CRUISER
AIRCRAFT

No.: SB-SC-078

SERVICE BULLETIN

| SUBJECT: | Rudder stops replacement |

Fig. 1: Rivets marked to be drilled out

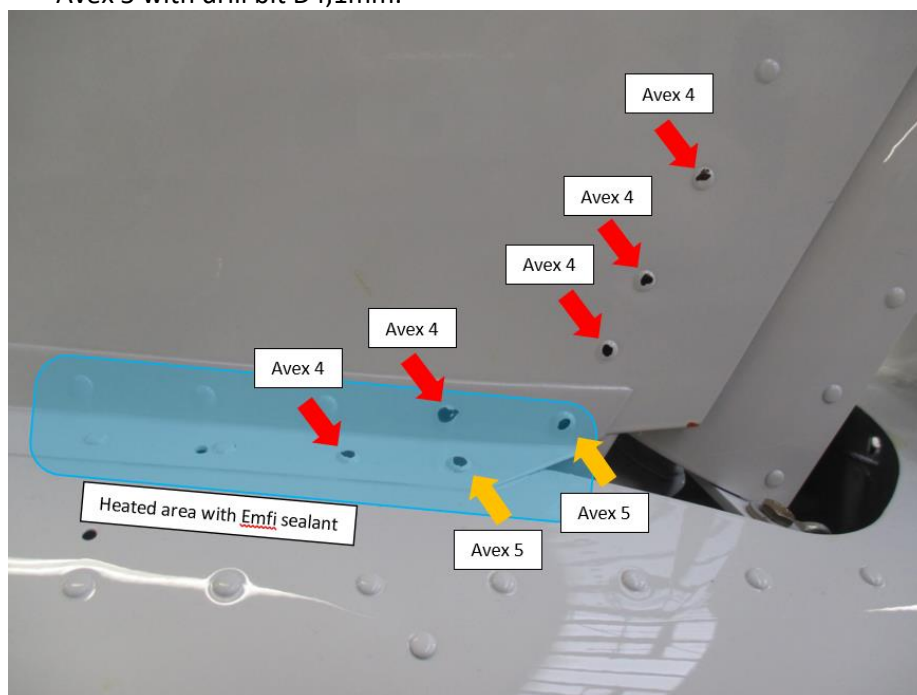
- 1) Remove horizontal stabilizer (SC_MM-1-0-00, Chap 5.3), disconnect trim wires and elevator rod.
- 2) Remove rudder (SC-MM-1-0-00, Chap 5.3), disconnect control cables.
- 3) Drill out the rivets both sides (SC-MM-1-0-00, Chapter 15.2). All drilled rivets are marked on the picture (Fig. 1). Rivets marked as Avex 4 with drill bit D3,2mm and Avex 5 with drill bit D4,1mm.

- 8) Install the left and the right stop, keep stops in contact with the mounting device.
- 9) Drill the holes, D3,2mm for Avex 4 and D4,1mm for Avex 5, see Fig. 1.

- 13) Gradually rivet (SC-MM-1-0-00, Chap 15.3) the rivets Avex 4-10 pcs. and Avex 5-4 pcs. See Fig. 1.
- 14) Remove the mounting device.
- 15) Clean the airframe from rest of rivets.

Fig. 2: Mounting device

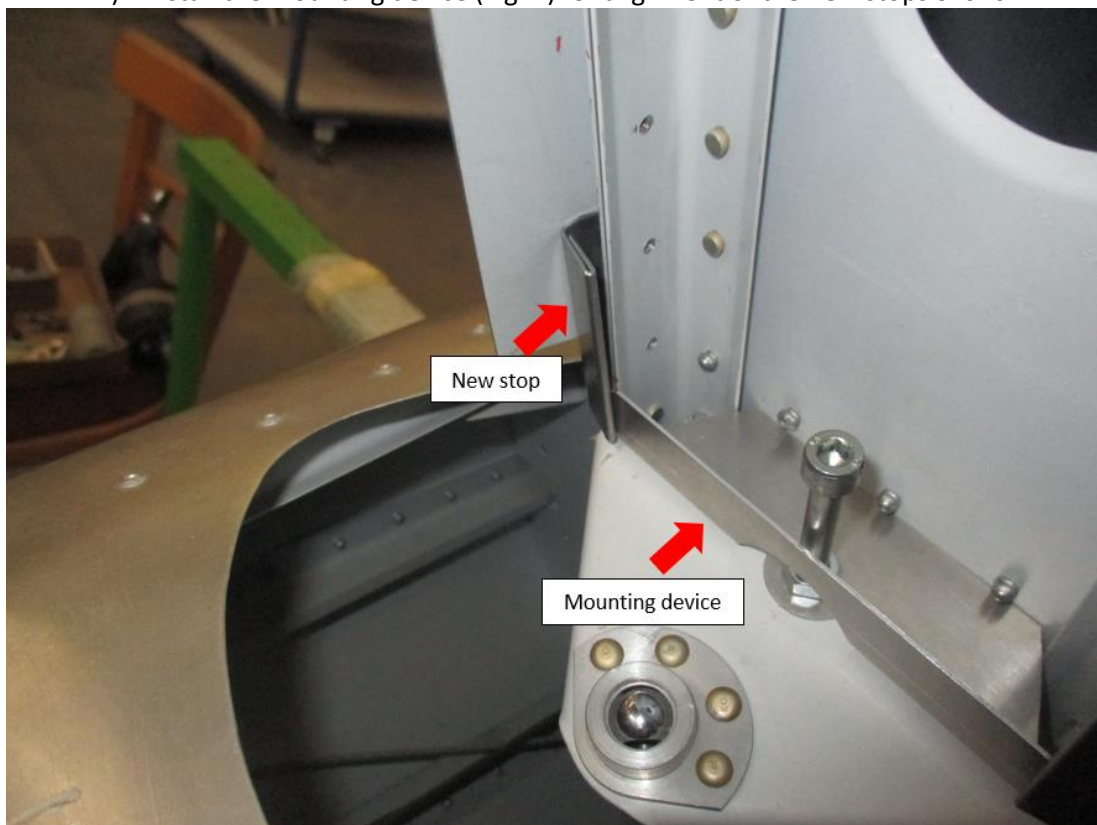
- 4) Gently heat up the fairing with a hot-air gun in blue area.
- 5) Remove the stops.
- 6) Remove any residual Emfi sealant using a snap blade knife.
- 7) Install the mounting device (Fig. 2) for alignment of the new stops SF0262LP.
